SLATER AVE REDEVELOPMENT - FRONTIER DRIVEWAY
A PORTION OF THE NW 1/4 OF THE SE 1/4 OF SECTION 28, TOWNSHIP 26 N, RANGE 5E, W.M.
CITY OF KIRKLAND, KING COUNTY, WASHINGTON

City of Kirkland - Slater Mixed-Use Project | January 26, 2021 | content: ROOF TOP DECK AMENITY

FILE: SLATER MIXED USE, DRV20-00621

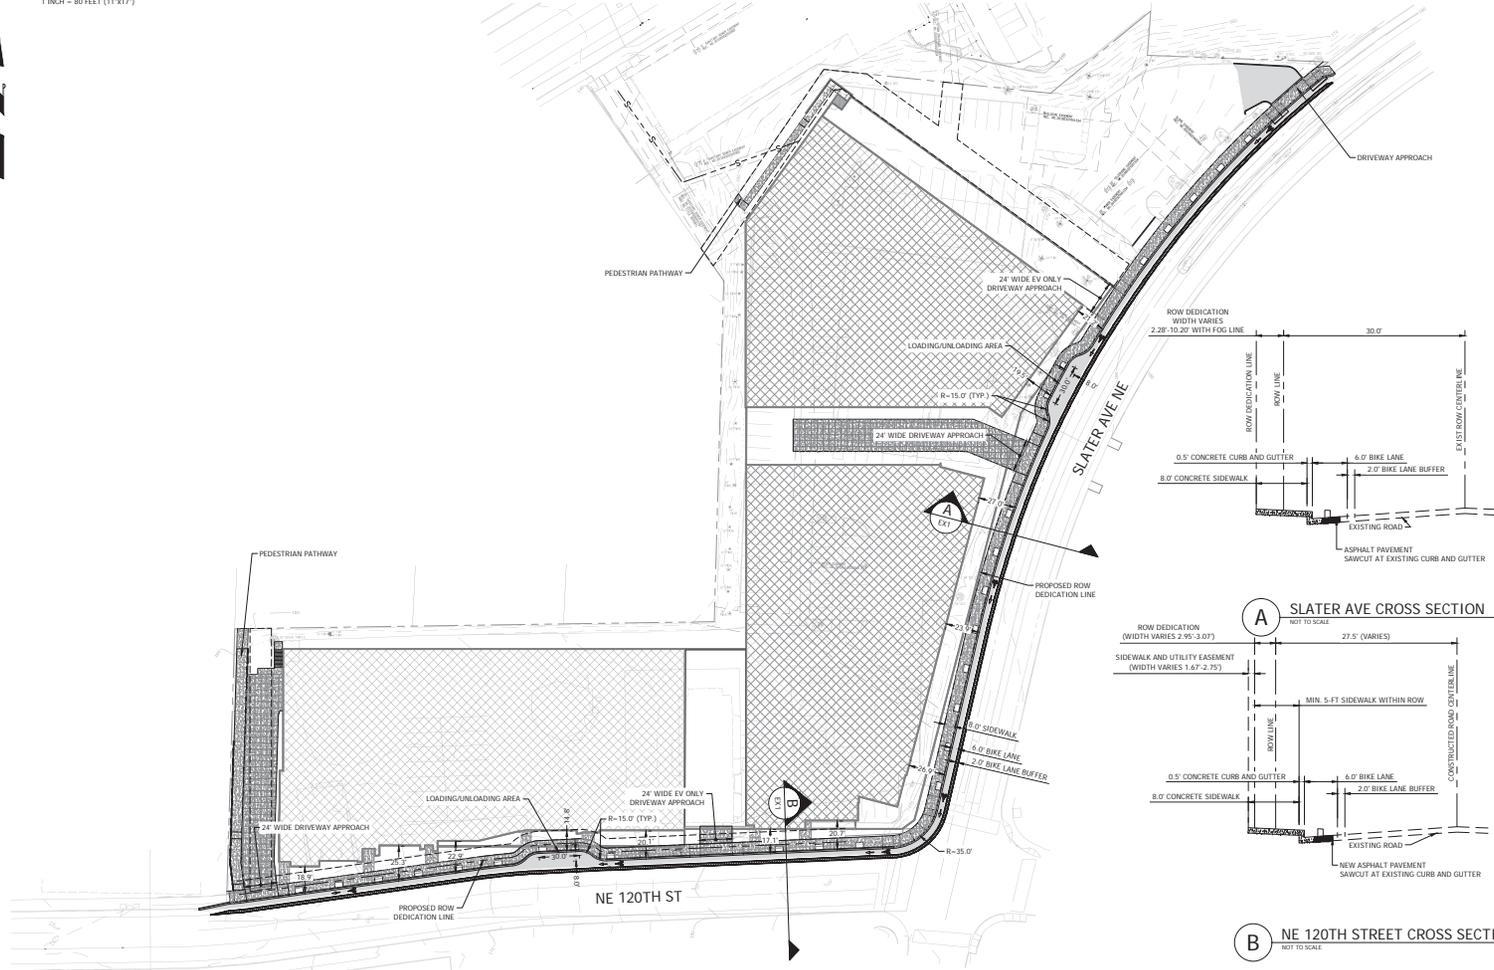
Provide an exhibit showing perimeter condition. Dimensions of public walk and any additional width beyond along 120th and Slater.

Exhibit provided showing street frontage and public walk improvements

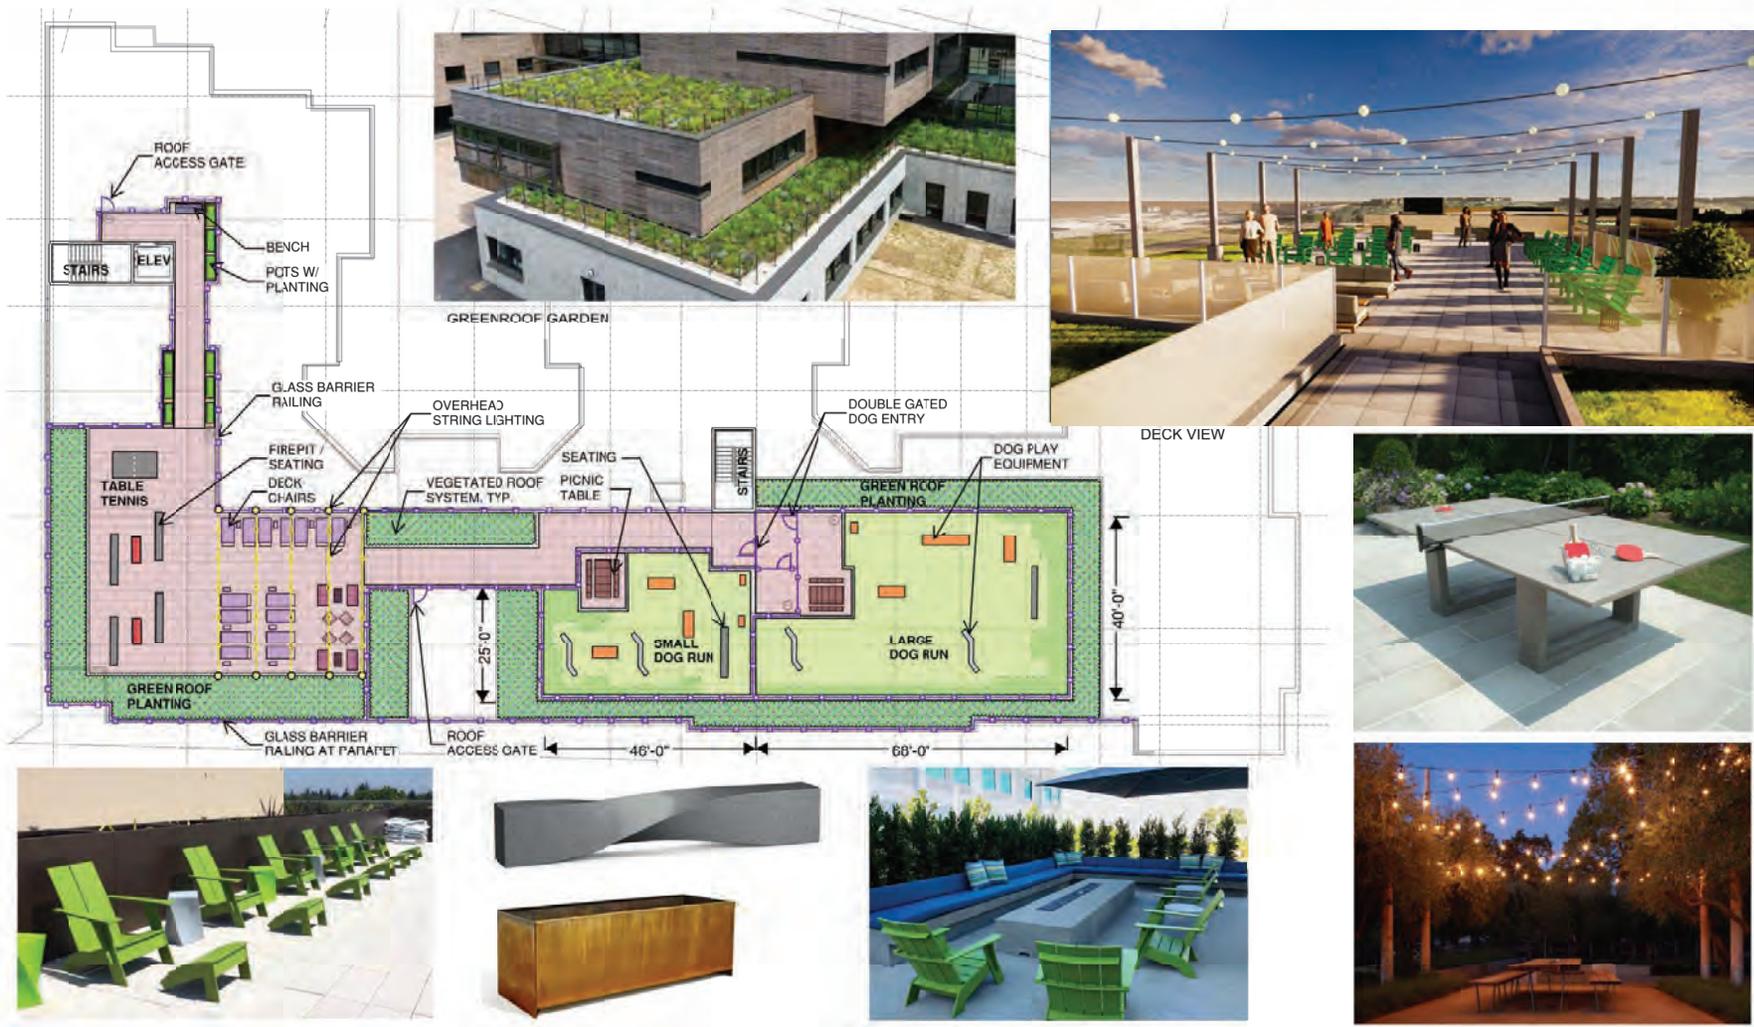
Request for project to include family friendly features.

Courtyards propose a variety of games as well as activity areas for gathering and enjoyment by a diverse resident community.

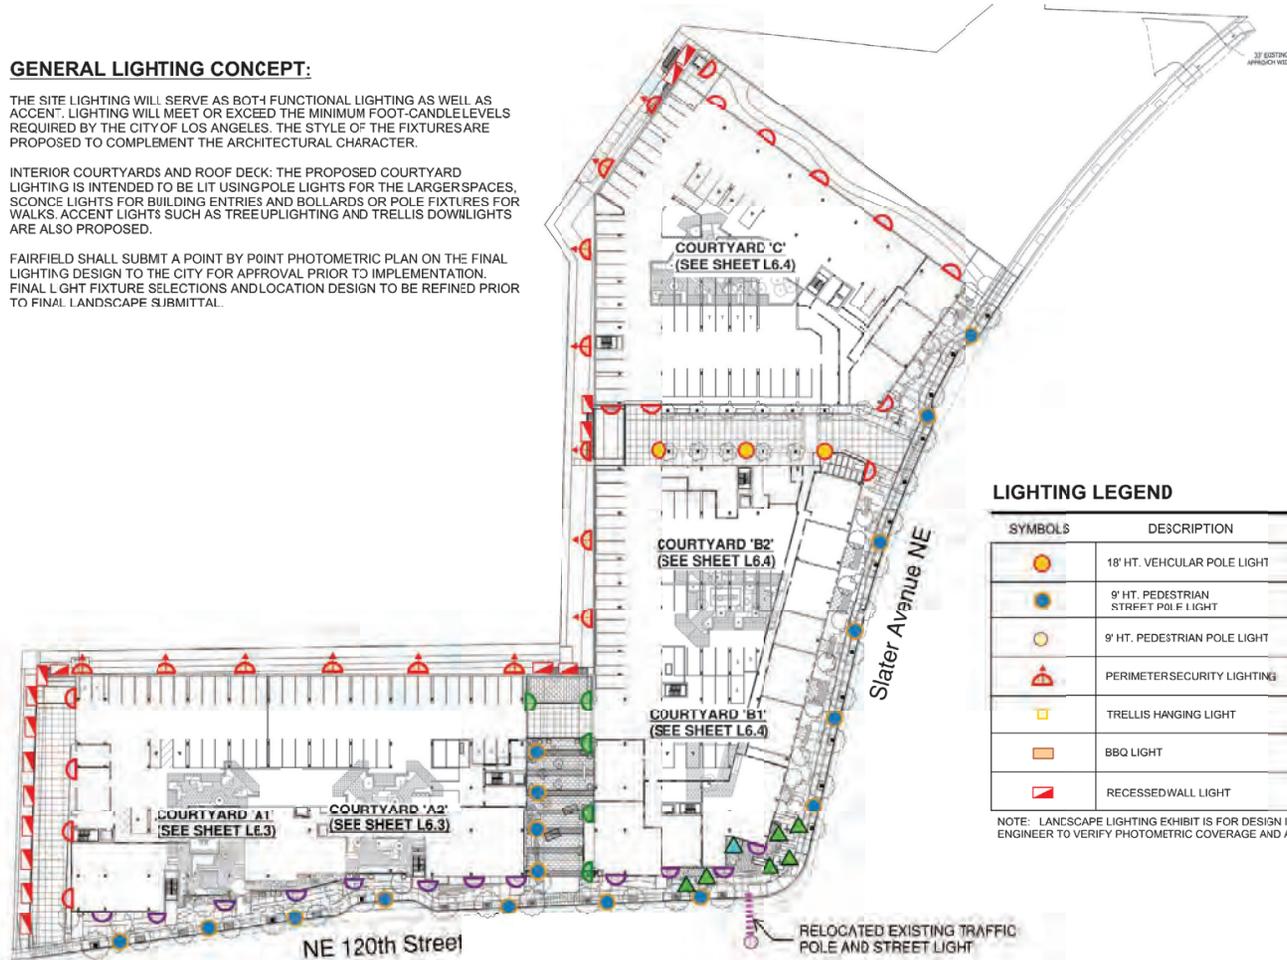
Need to provide a lighting plan.

Lighting plan included to show proposed lighting at ground level and residential courtyards
